**Piceance Energy LLC
Harrison Creek Water Treatment
Facility – DAF Unit**

OA Project No. 014-0465

March 18, 2015

Olsson Associates (Olsson) has reviewed the *Drainage Report for Harrison Creek Produced Water Recycling Facility Mesa County, Colorado* prepared by Rhino Engineering, Inc. Revised June 25, 2009 (Report). Additionally, Olsson has reviewed the Harrison Creek Water Treatment Facility Civil Layout and Grading Plan prepared by Samuel Engineering, signed and sealed March 18, 2015 (Grading Plan). The purpose of the review is to determine whether the Grading Plan is in general conformance with the Report. Calculations and study is not included with this review.

EXHIBIT 3
POST-DEVELOPMENT DRAINAGE MAP
HARRISON CREEK PRODUCED
WATER RECYCLING FACILITY
MESA COUNTY, COLORADO

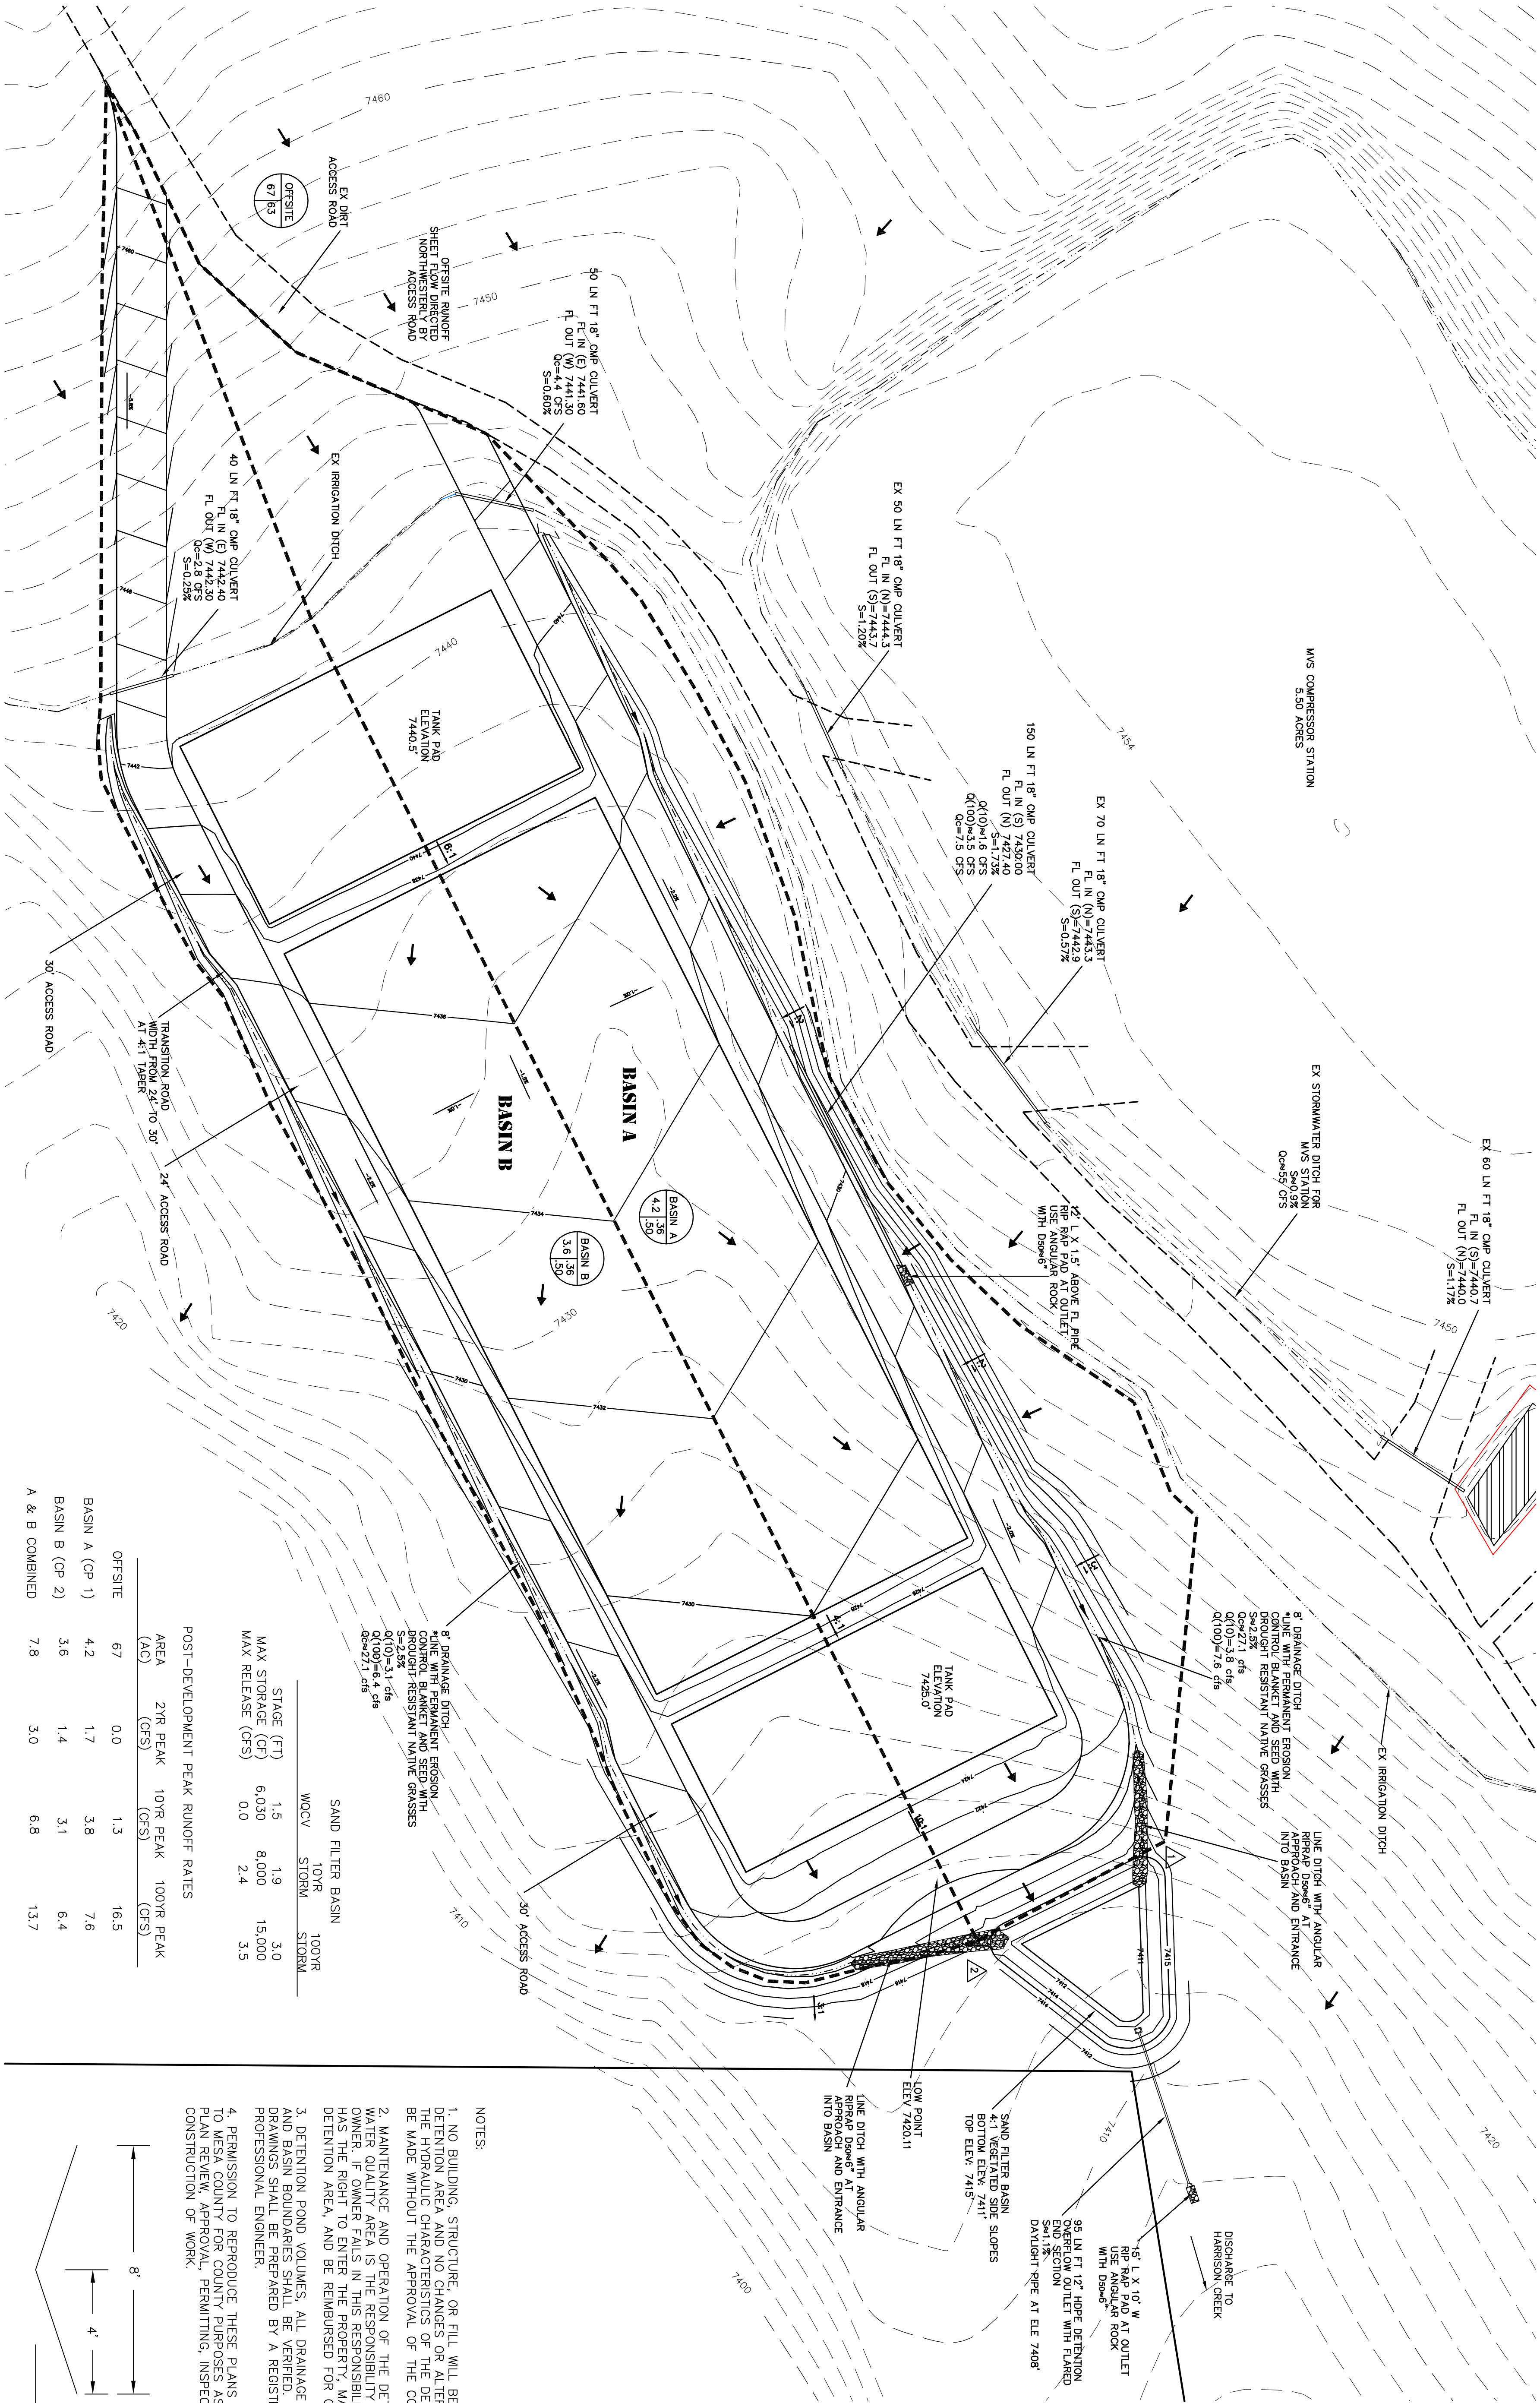
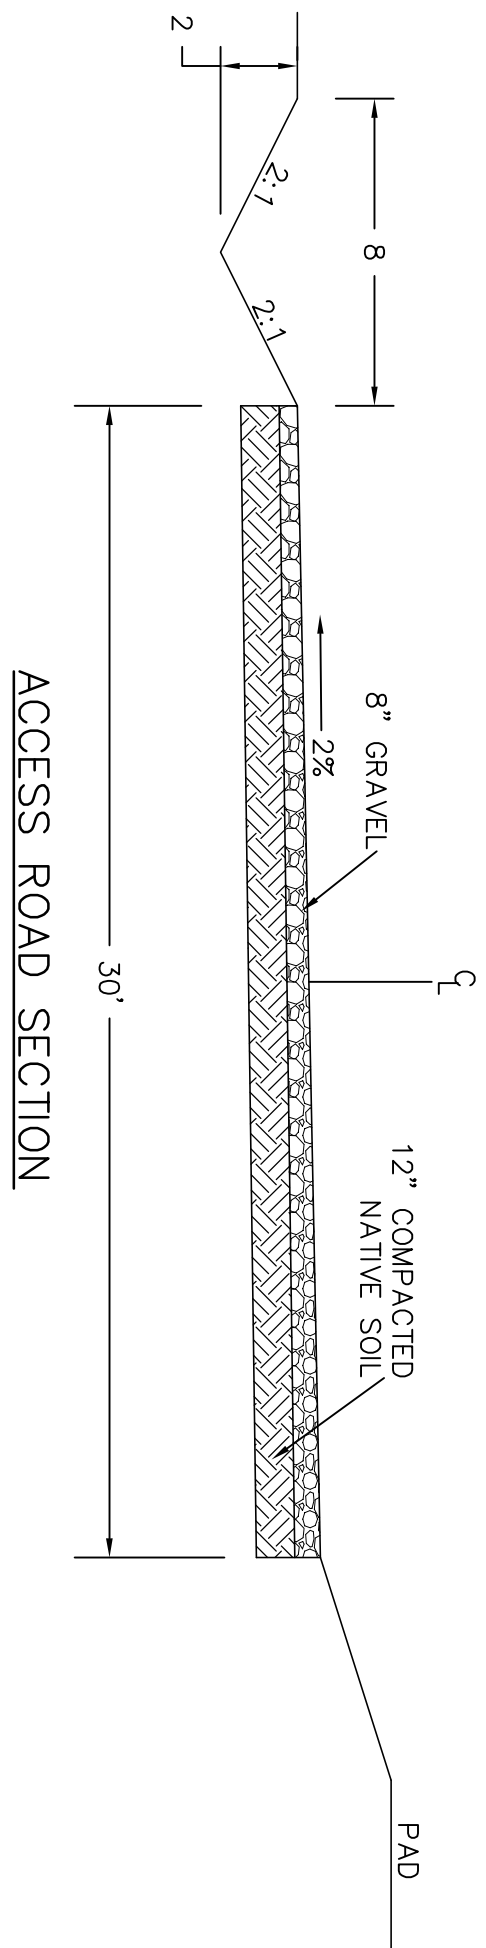
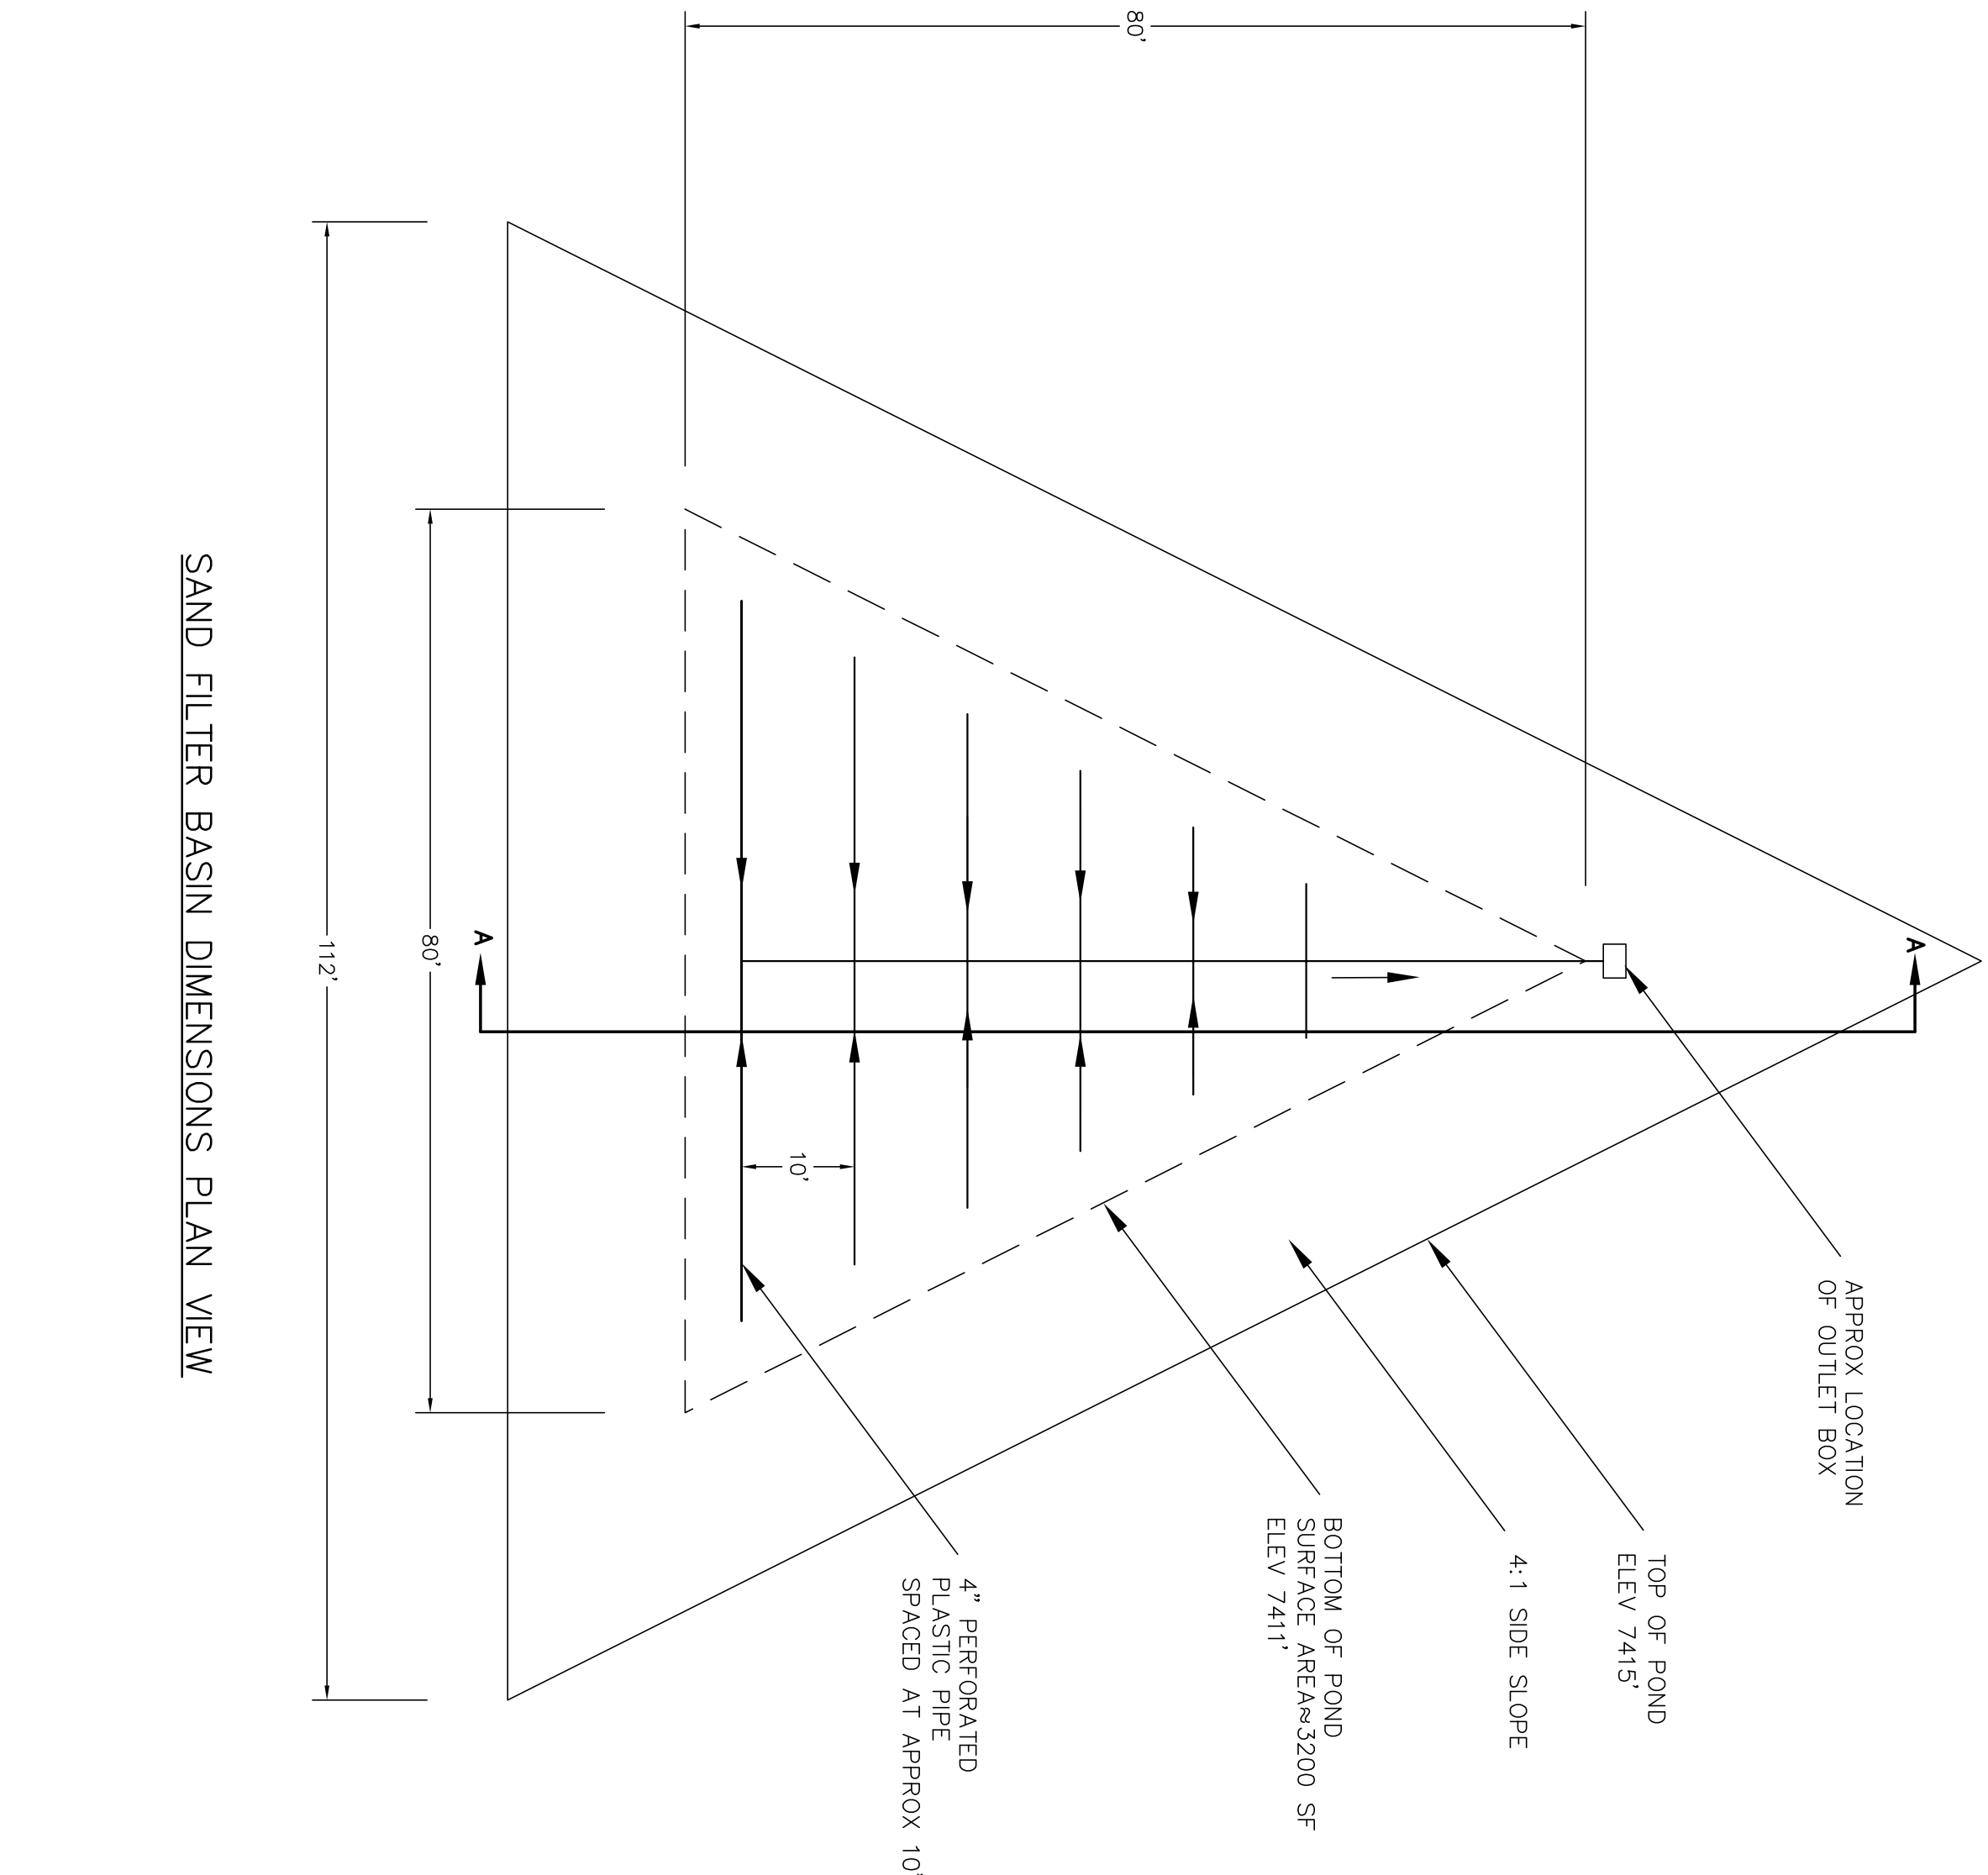
- The Report indicates there are two 18" CMP culverts on the south end of the site
 - The culverts convey the existing irrigation ditch under the perimeter access roads
 - The Grading Plan identifies culverts, however, the size is not indicated
- The Report indicates an 18" CMP culvert within the conveyance swale along the west side of the site

- The Grading Plan does not indicate the culvert, however, it shows the V-ditch along the entire length
- The Report indicates that the Sedimentation Basin shown within the grading plan is a detention basin
 - The Report indicates there is a 12" HDPE outlet pipe, however, the Grading Plan does not indicate that there is an outlet pipe
 - Additionally, the Report indicates the pond bottom to have an elevation of 7411 feet with a top elevation of 7415 feet, however, the Grading Plan indicates the pond bottom elevation is 7421 feet and it appears the top elevation may be 7425 feet

1. The detention pond described within the Report appears to be of similar volume, similar side slopes, and similar depth, however, it does not appear to function as designed. The Report designed the pond to release the flow through an outlet pipe. The Grading Plan appears to treat the pond as a sedimentation basin and does not allow for an outflow. The outflow would require overtopping the pond.

2. The west conveyance ditch is designed within the Report to include a culvert in a portion of the ditch. This appears to have been included due to grading constraints that would prevent an open channel ditch.

It is recommended that the detention pond be modified to include the outlet pipe as designed within the Report. Alternatively, the existing pond could be modified to include a weir outfall to meet the intent of the pond release designed within the Report.

It is recommended that this area be investigated further to determine that the ditch section is maintained throughout the area and verify that the grading anticipated within the Report was modified to allow for an open channel. Alternatively, a culvert may need to be installed to meet the design intent of the Report should additional verification confirm that the channel section does not meet the intent of the design of the Report.
